MARYLAND DEPARTMENT OF THE ENVIRONMENT
Oil Control Program, Suite 620, 1800 Washington Blvd., Baltimore MD 21230-1719
410-537-3442 410-537-3092 (fax) 1-800-633-6101, ext. 3442

March 25, 2014

RE: RESPONSES TO QUESTIONS
Case No. 1987-2534-KE
Chester River Hospital Center
100 Brown Street, Chestertown
Kent County, Maryland
Facility I.D. No. 3168

CROSS SECTION A-A'

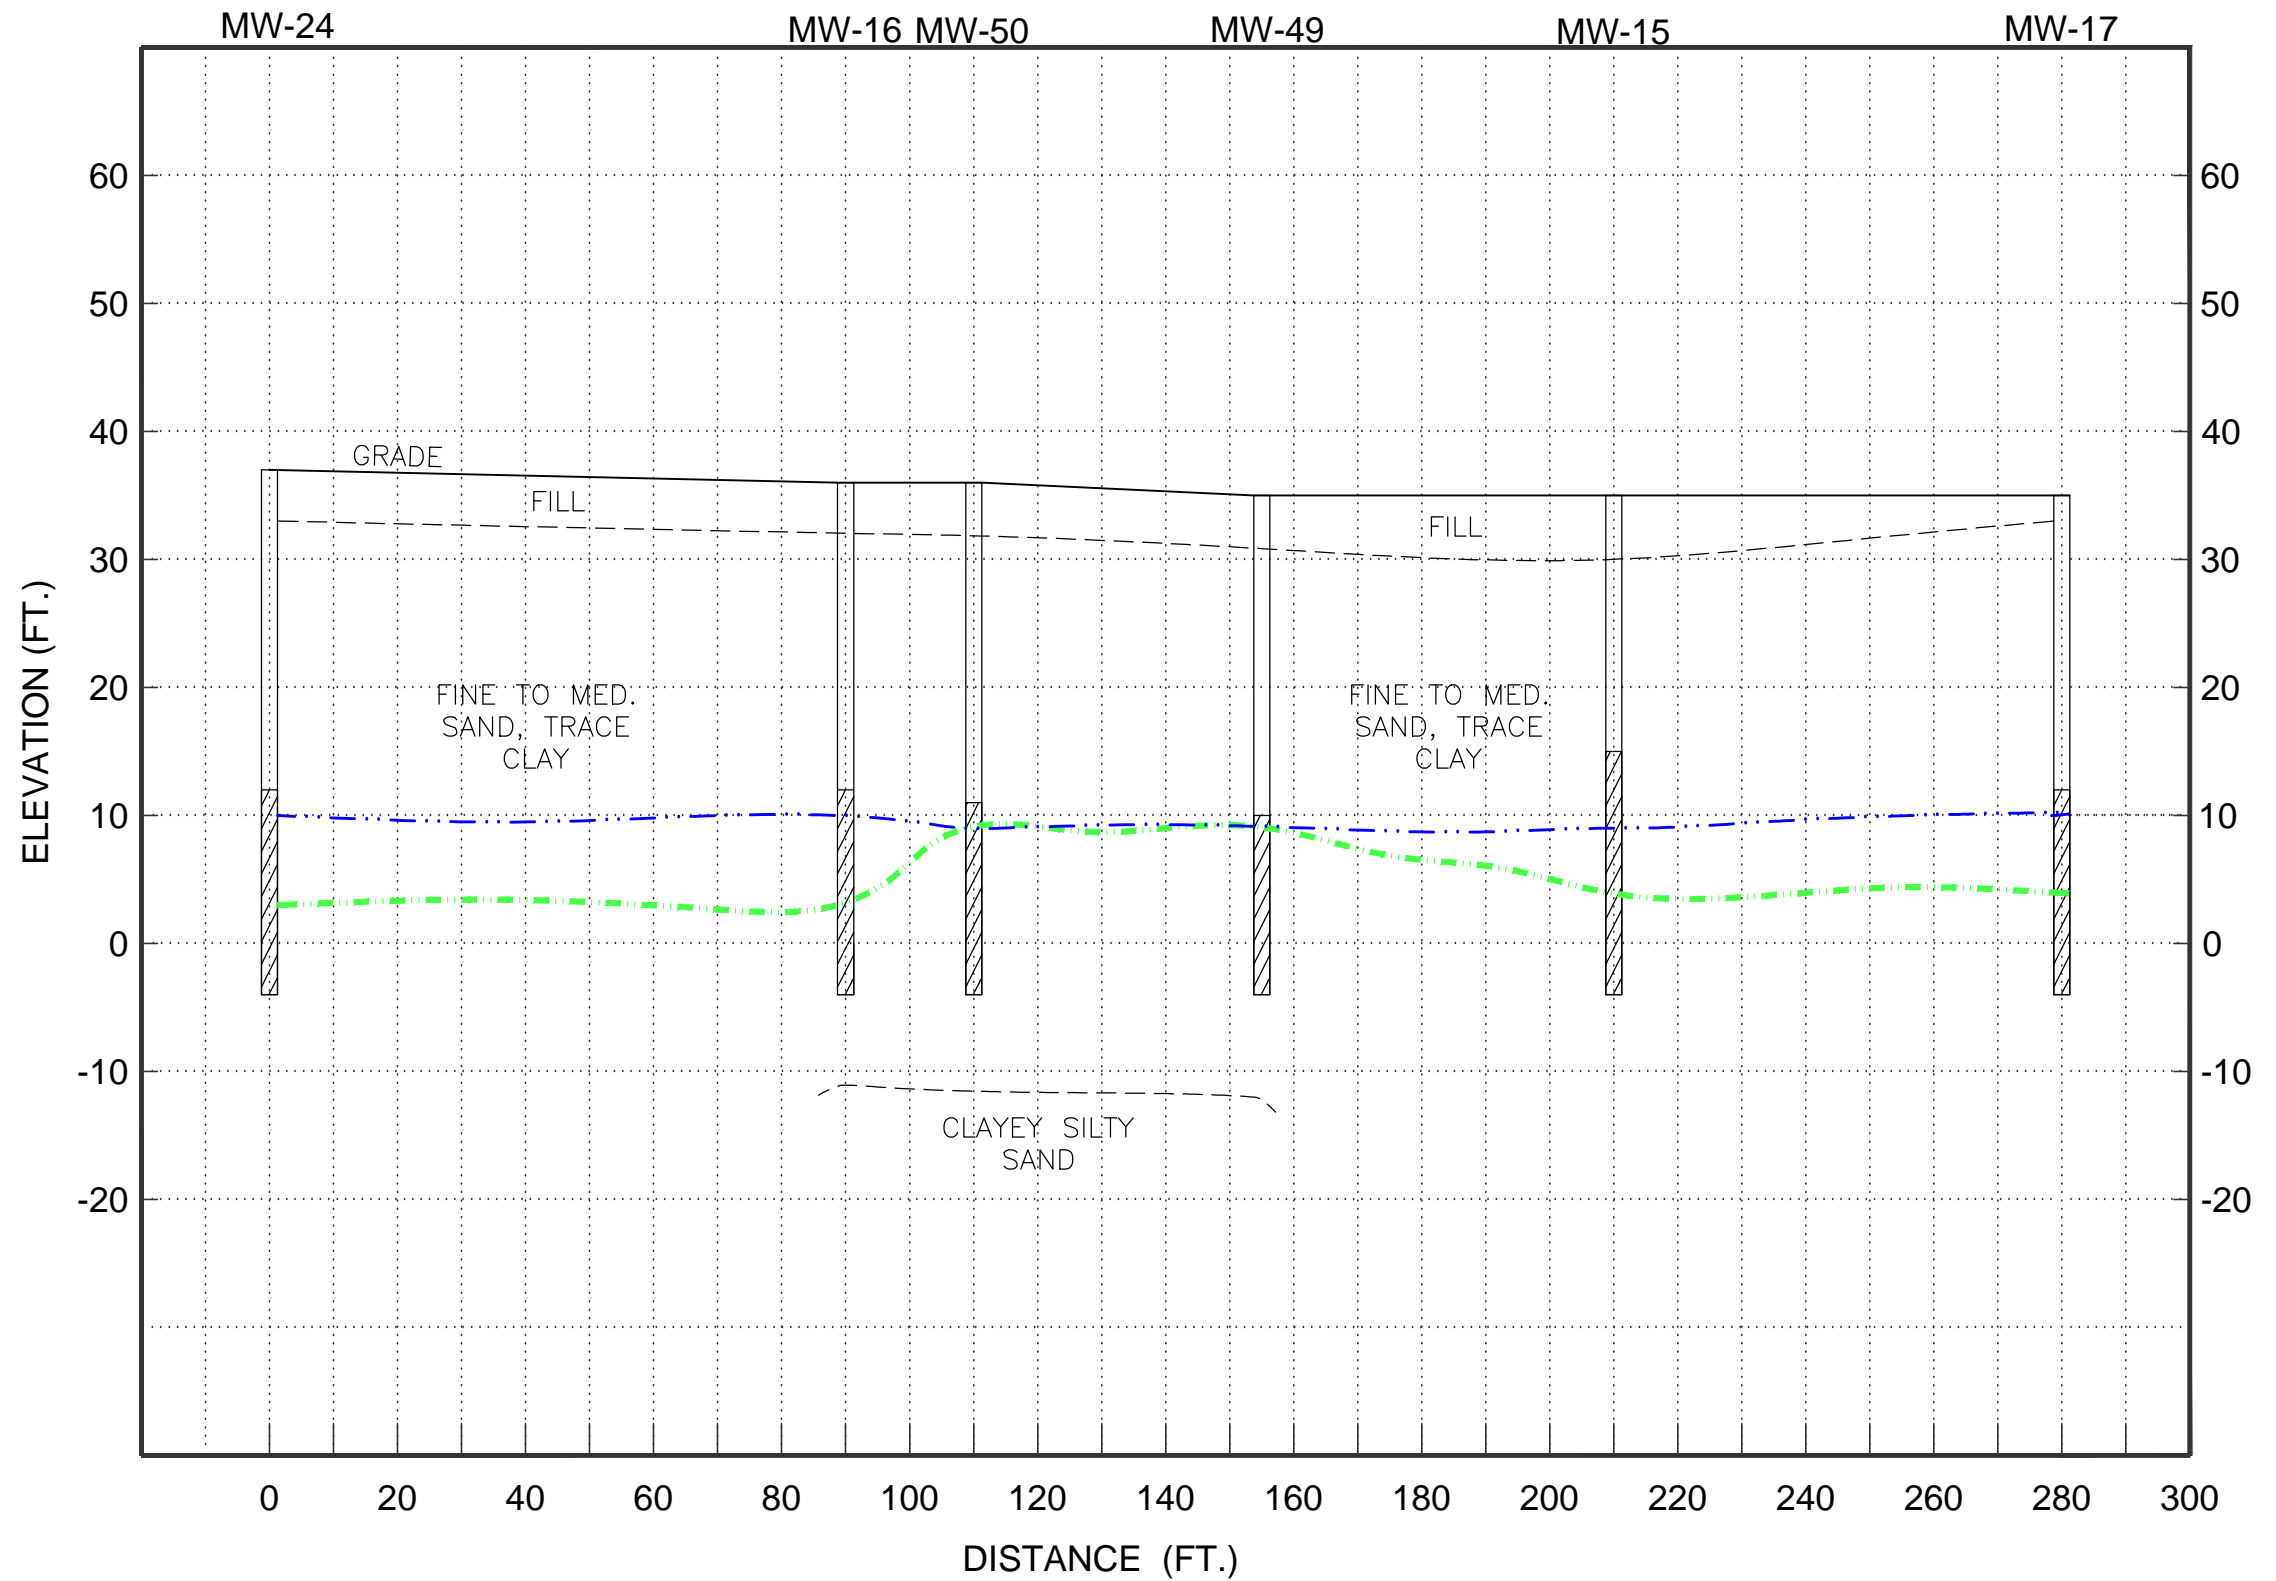
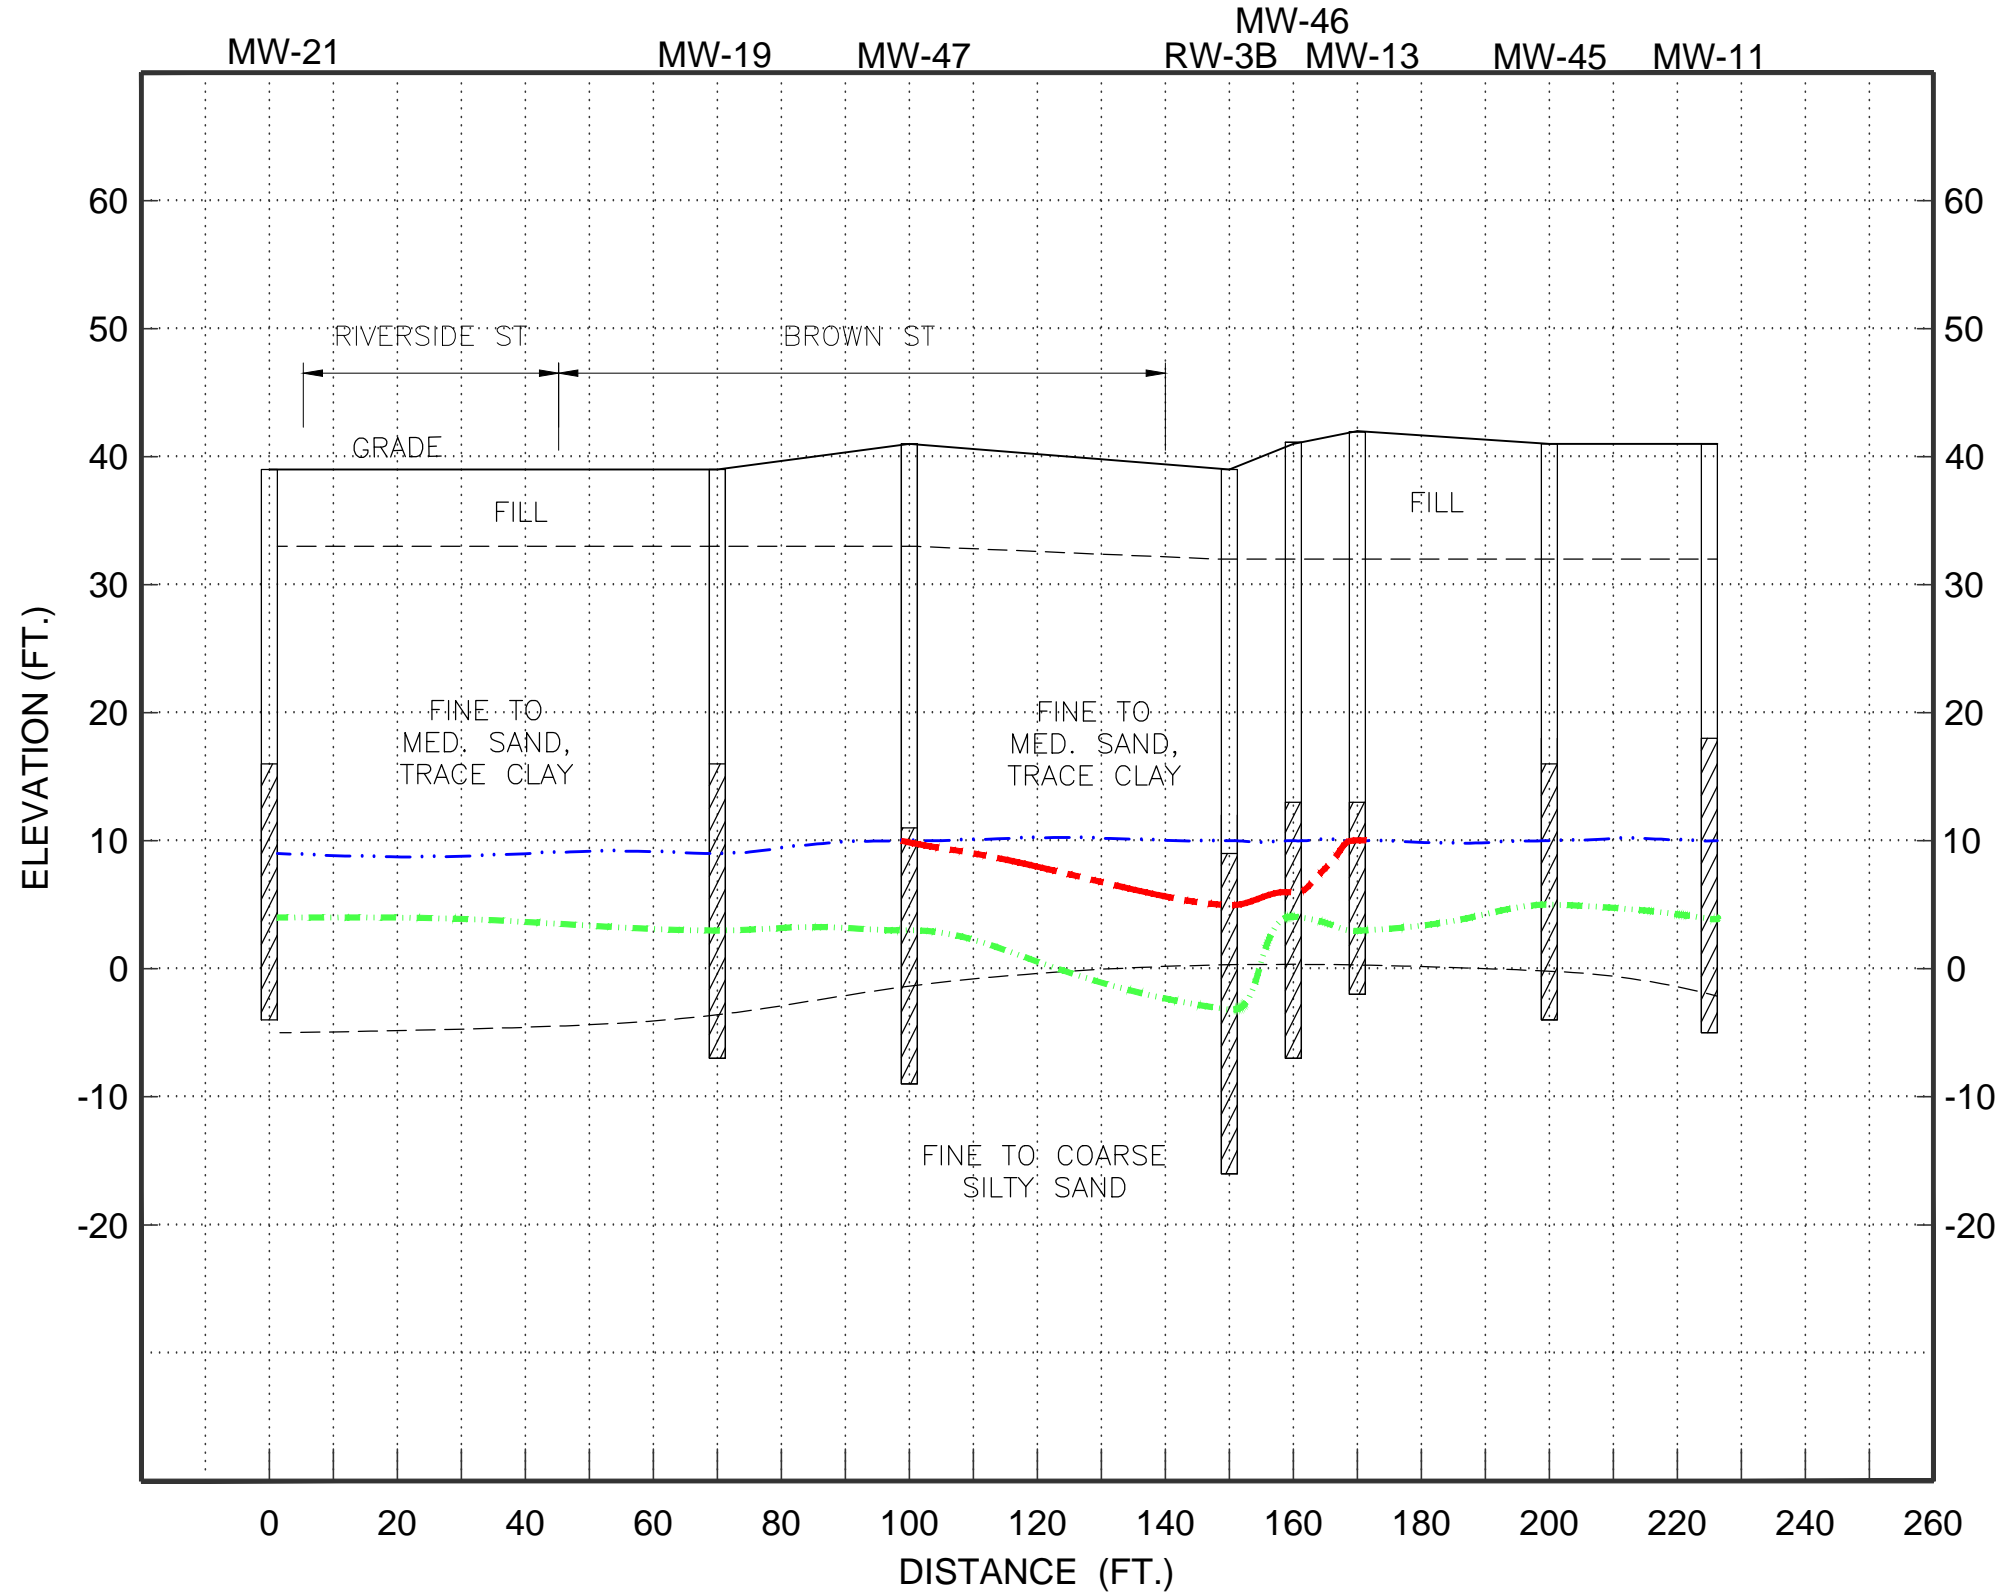
As demonstrated in the attached cross-sections, the subsurface geology is relatively uniform and the smear zone is adequately characterized. The existing well network adequately covers the site and the monitoring wells are constructed to depths that coincide with the upper portions of the municipal wells.
